Marina Coast Water District

Imjin Office Park Side B
Improvements Project (WD-2401)

Bid Amendment 4

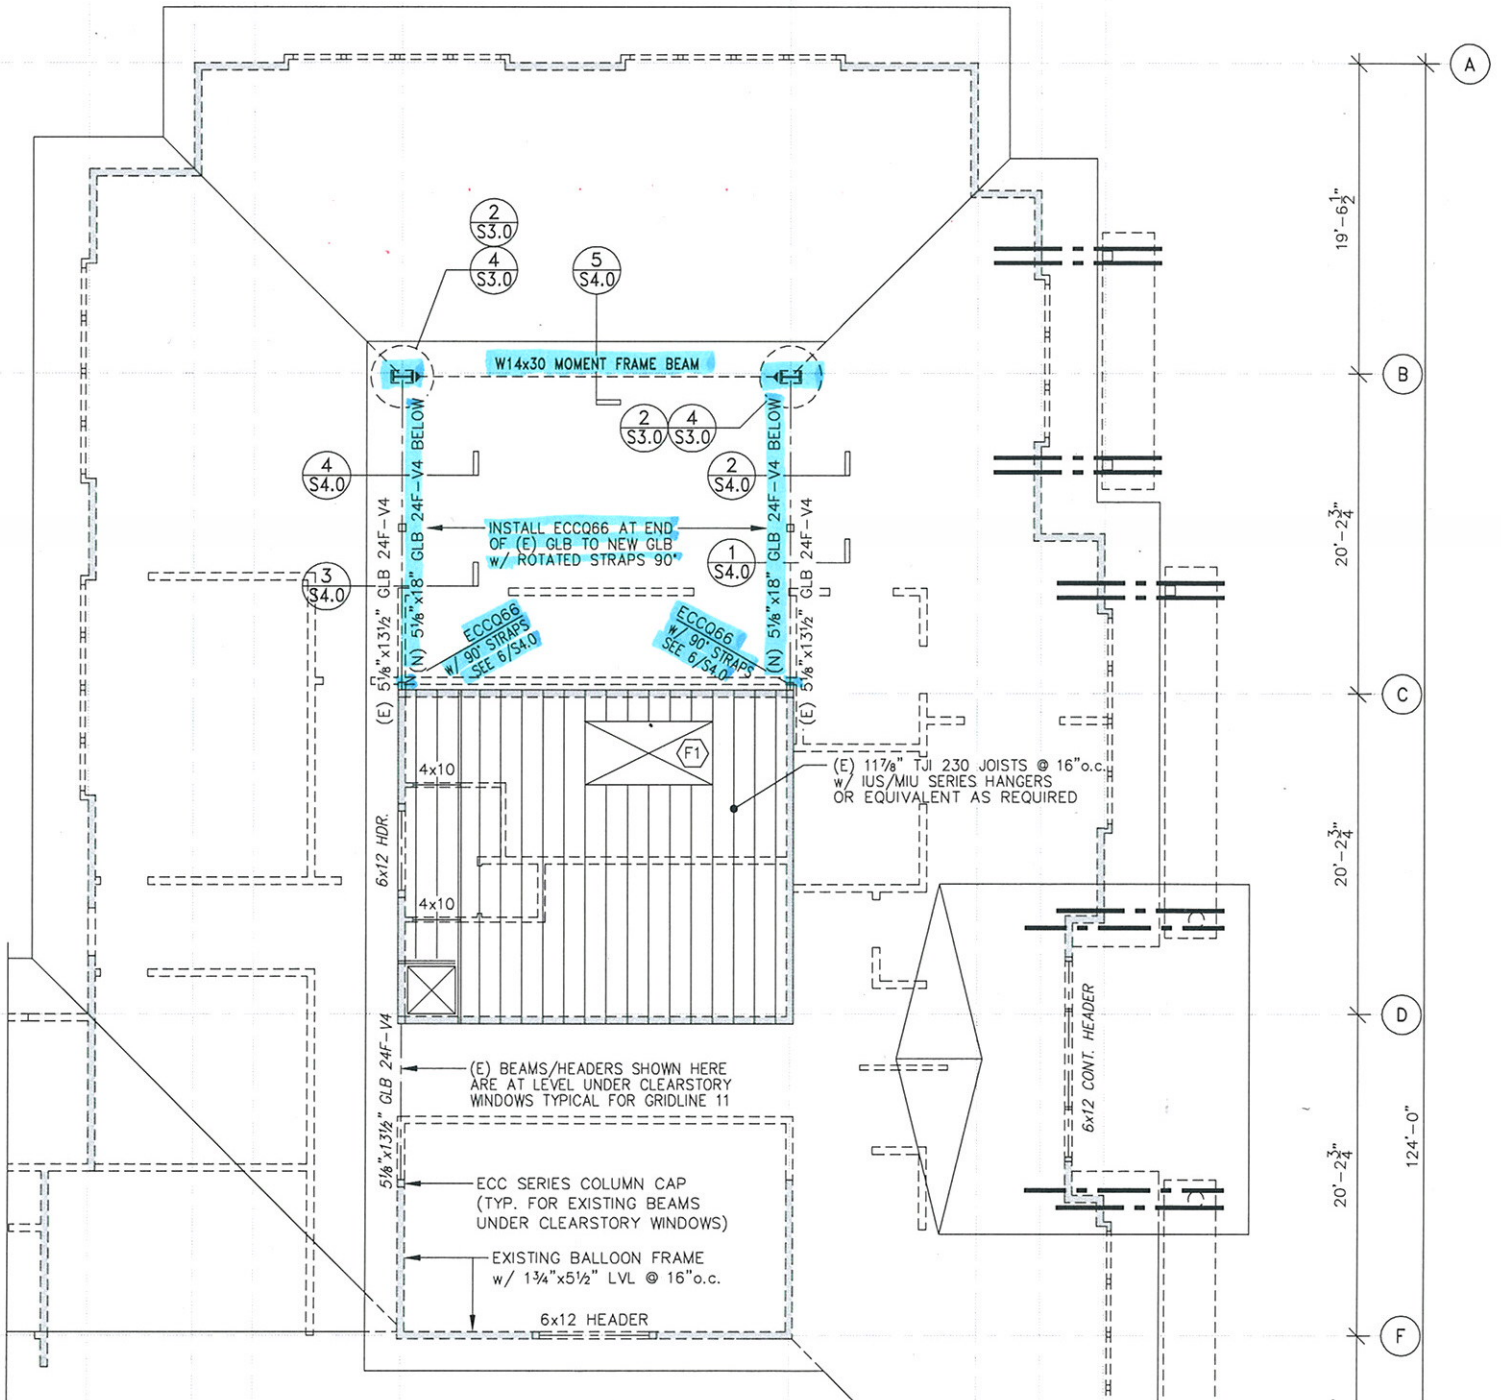
31. Detail (7/A9.2) shows a new 1-hr. rated wall (Rm. #109) next to the existing women's restrooms wall, see below. Is it acceptable to install the one layer of GWB (pink) on the existing restrooms plywood wall and then frame the wall with the shown 2 layers on the face of the new wall (blue), this will still provide the required 1-hr. rating. Please advise.

Response: This is acceptable. See revised detail 7/A9.2.
32. RCP plan calls for detail (9/A9.2) for rooms 110/111, but detail (7/A9.2) for Toilet #111 calls for joists and plywood. Please confirm we are to use detail (7/A9.2)? Please confirm this ceiling detail also applies to room #110 or is there an elevation you can provide?

MECH LOFT CEILING LEVEL

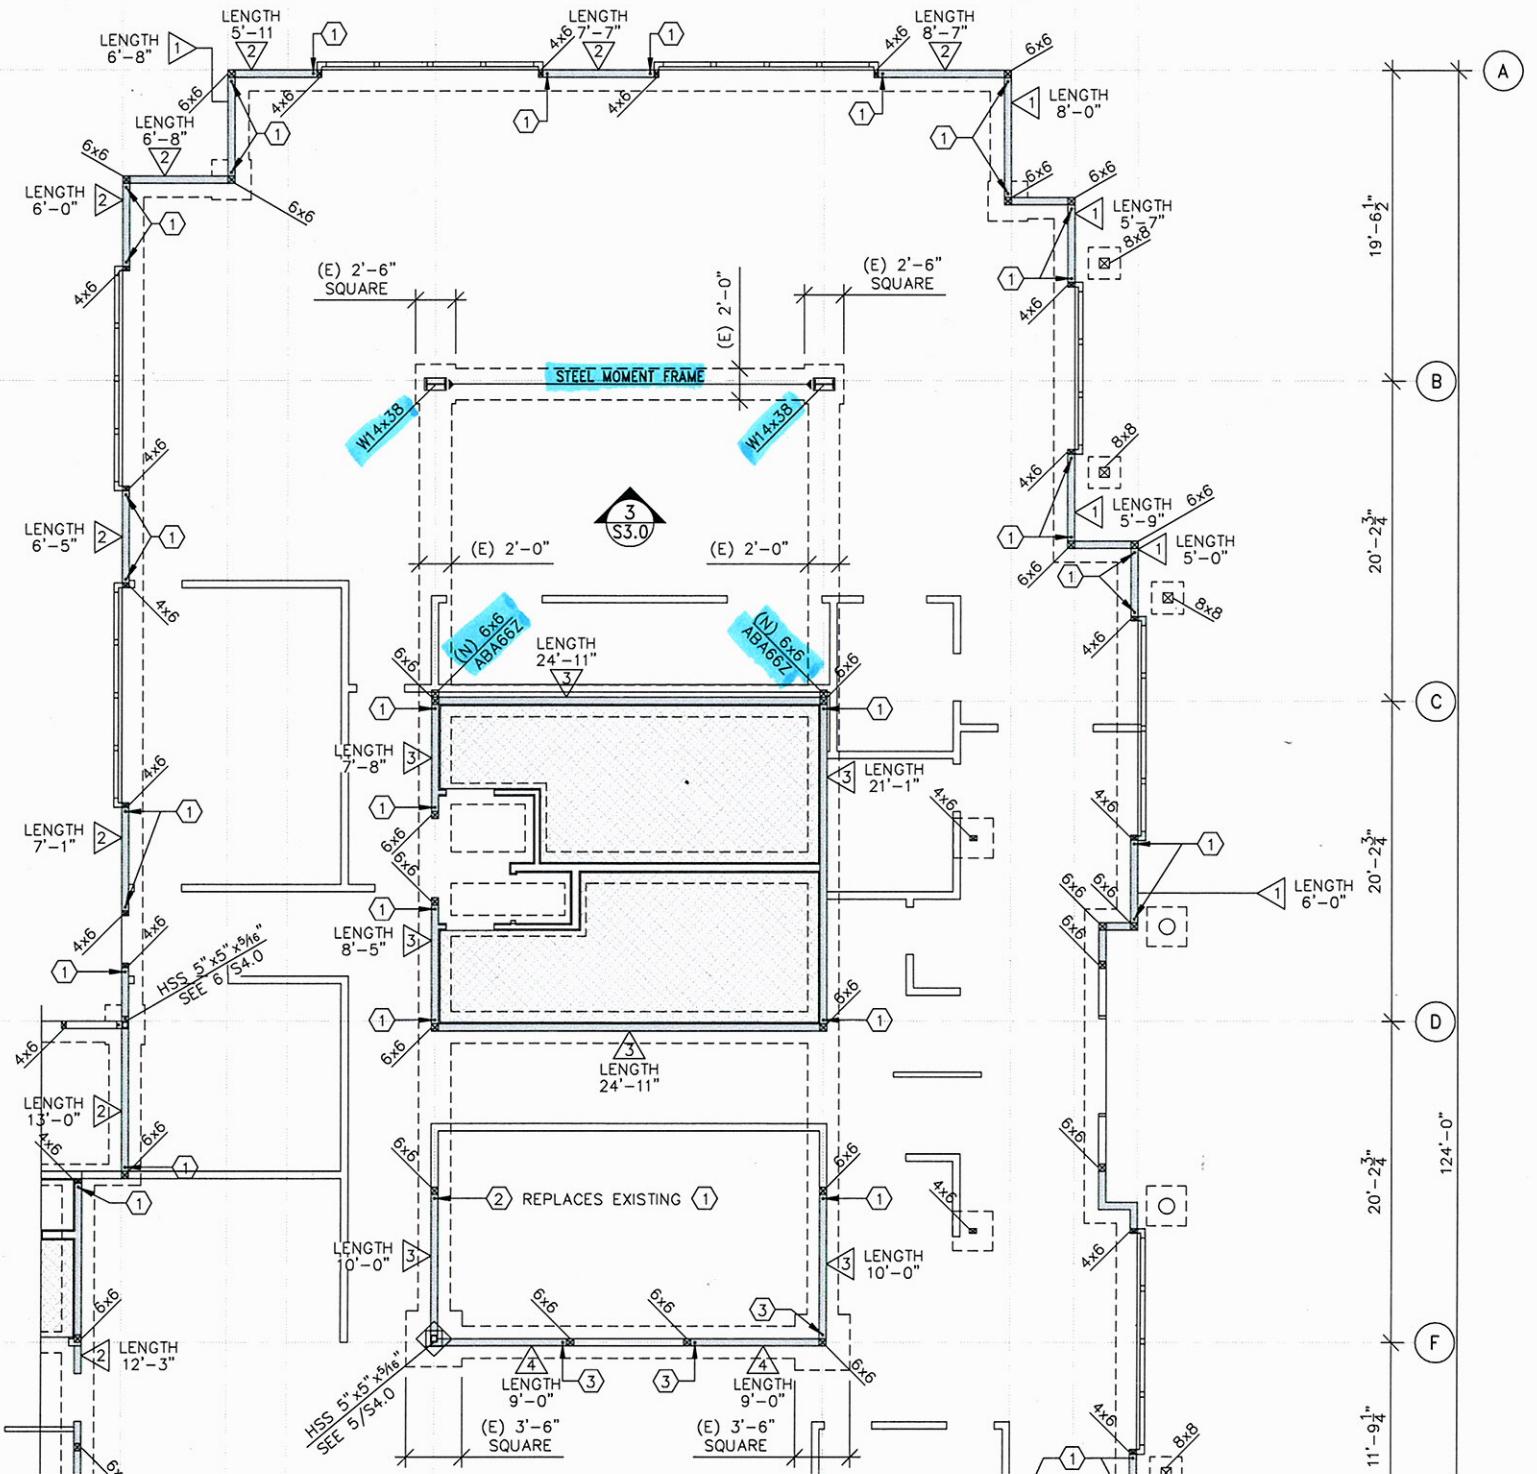
35. It is a little unclear on what the new columns/wood and steel in the current structural plans. Can you please clarify which are new and which are existing? Are there new hip beams on moment frame? Are there any new steel columns besides the new moment frame?

Response: See structural response attached.

HIGHLIGHTED ITEMS ARE NEW
 THE REST ARE EXISTING
